METROPOLITAN GOVERNMENT OF NASHVILLE AND DAVIDSON COUNTY

STAFF RECOMMENDATION 917 Petway Avenue July 16, 2014

Application: New construction - infill
District: Greenwood Neighborhood Conservation Zoning Overlay
Council District: 06
Map and Parcel Number: 08204038800
Applicant: Ashli Williams
Project Lead: Paul Hoffman, paul.hoffman@nashville.gov

Figure 3. Discrepancies between the existing front façade compared to the elevation submitted

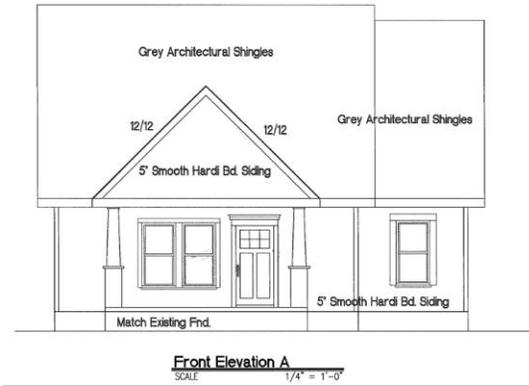
Design: There are a few discrepancies with the drawings to be resolved. The drawings submitted indicate that the front gable has a 12/12 pitch, while inspection reveals that it is 6/12. The drawings also show the position of the front door and window reversed. The applicant states that she does not intend to make these changes, so Staff has requested that the drawings be revised to depict more accurately the existing conditions, prior to a permit being issued.

- Drawings be revised to reflect what is actually proposed;
- Windows be added to the first floor of the side elevations;
- HVAC and other utilities be located on a rear façade, or on a side facade beyond the midpoint of the house, if a new location is necessary; and,
- Staff have final approval of trim and porch materials, windows and doors.

Right Side Elevation
SCALE 1/4" = 1'-0"

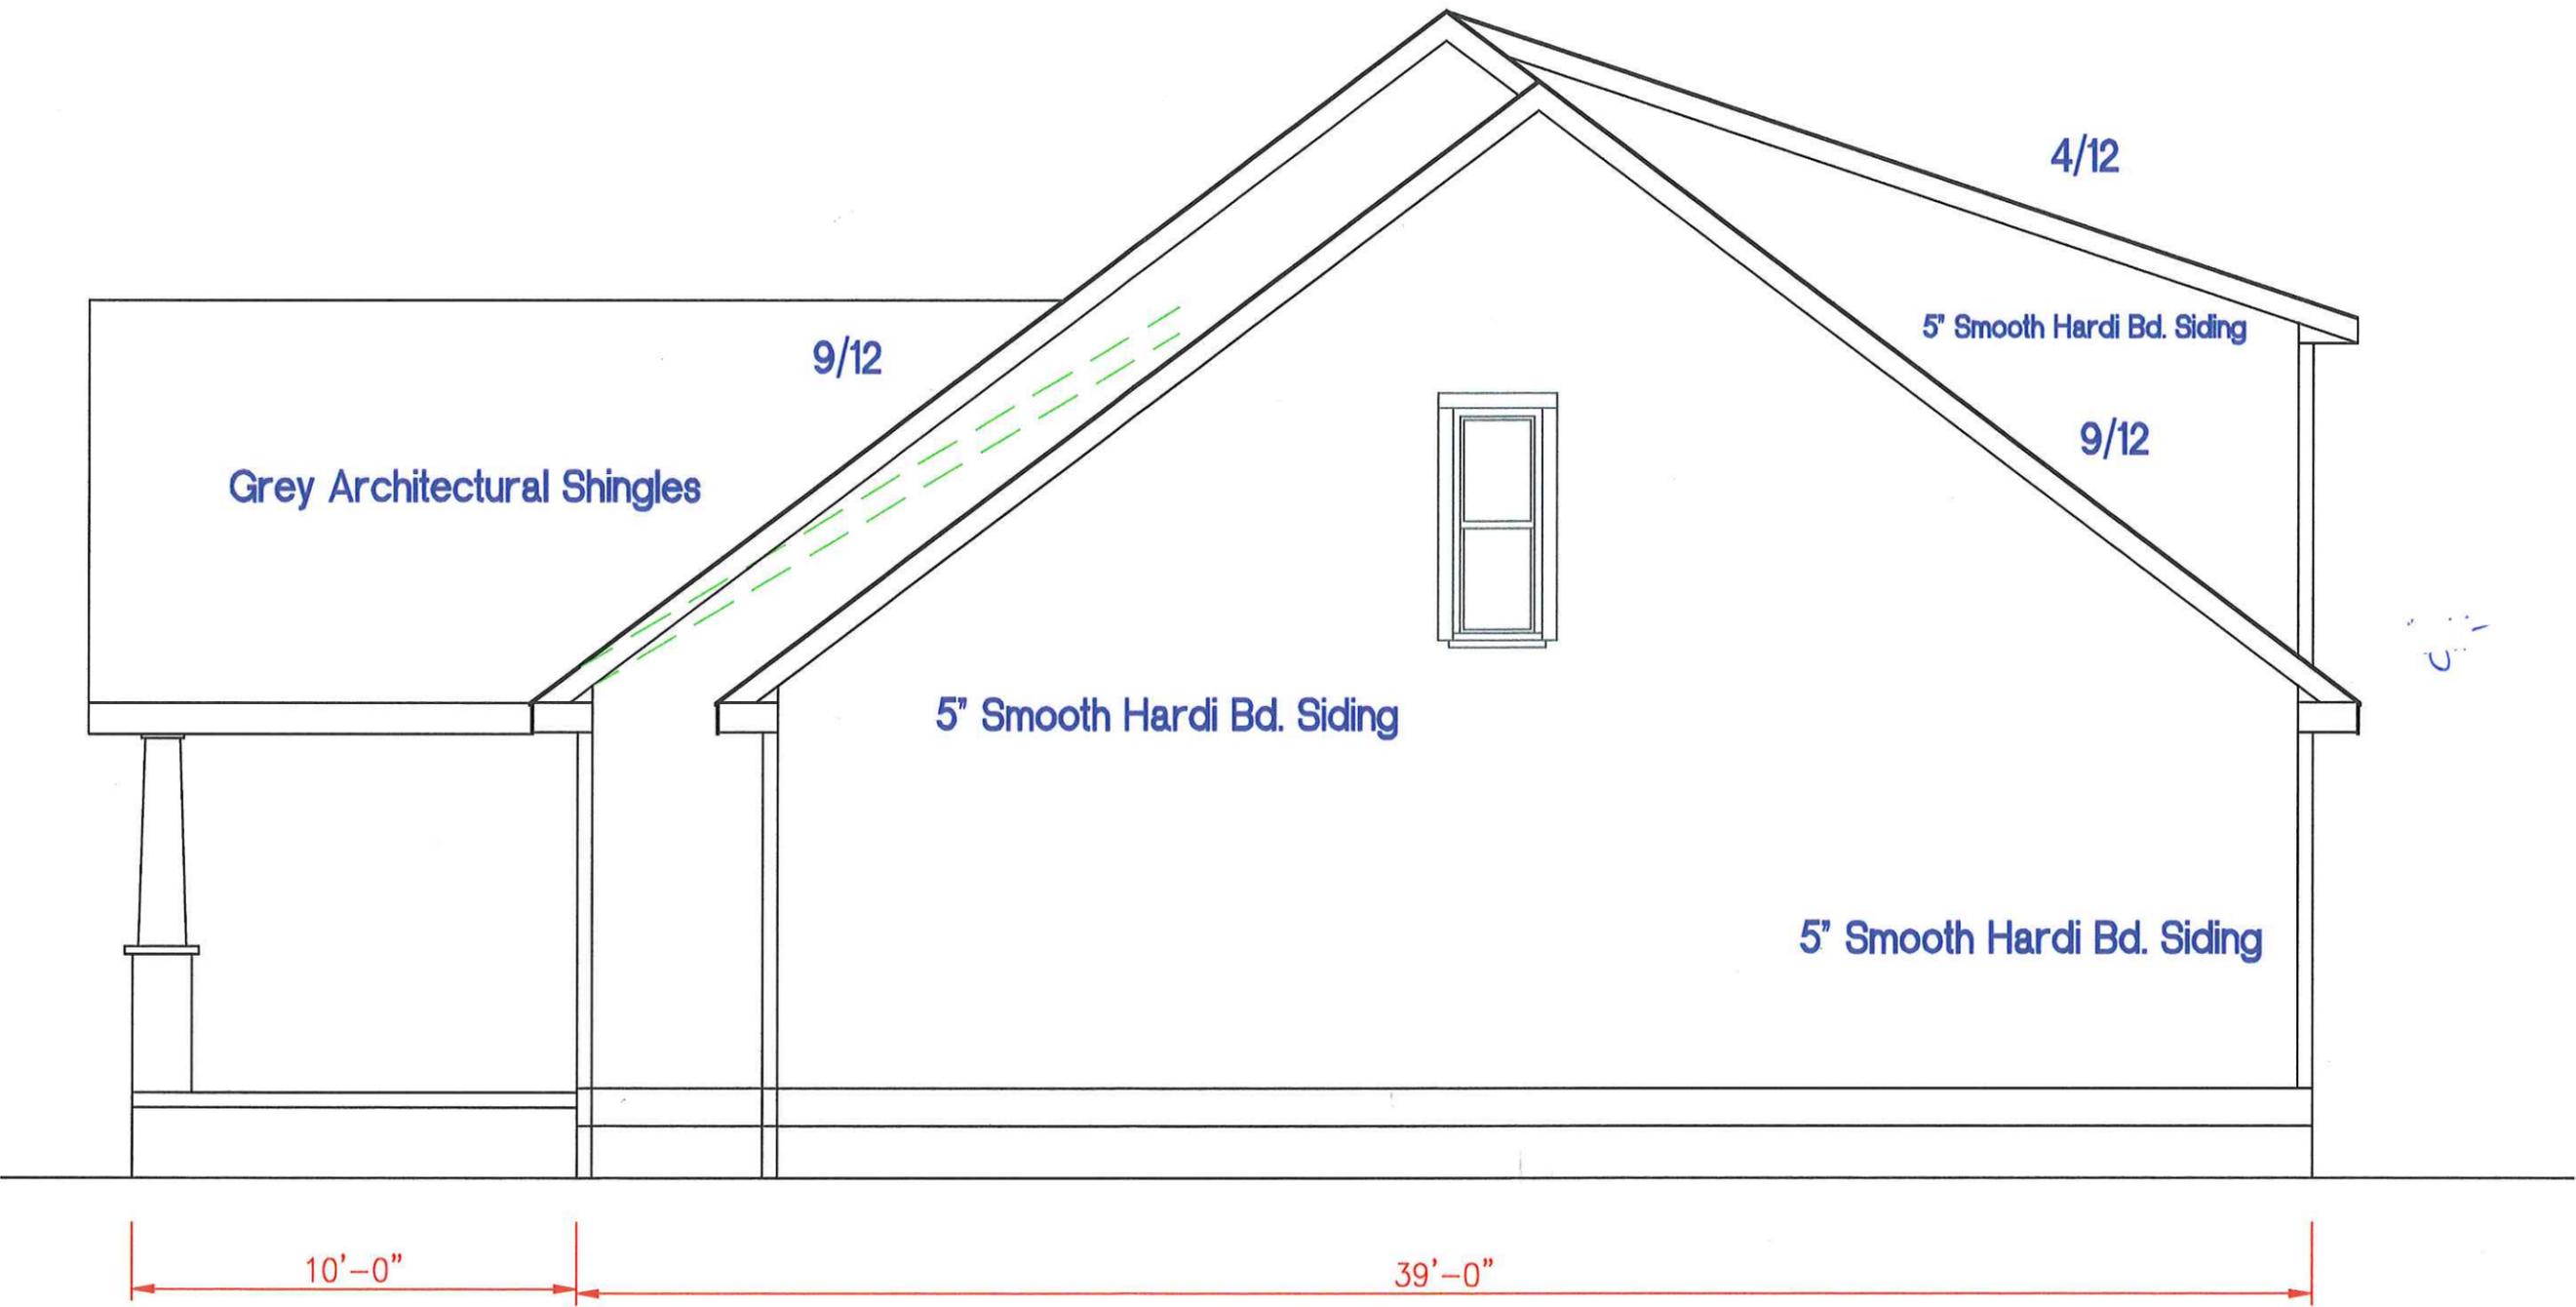
Proportion and Rhythm of Openings: The drawings submitted show no windows on the side elevations on the ground floor. It is unclear if this is the applicant's intent, but Staff has requested two or three windows be added to those elevations. With this condition, the project will meet section II.B.1.g of the guidelines for proportion and rhythm of openings to meet Section II.B.1.g.
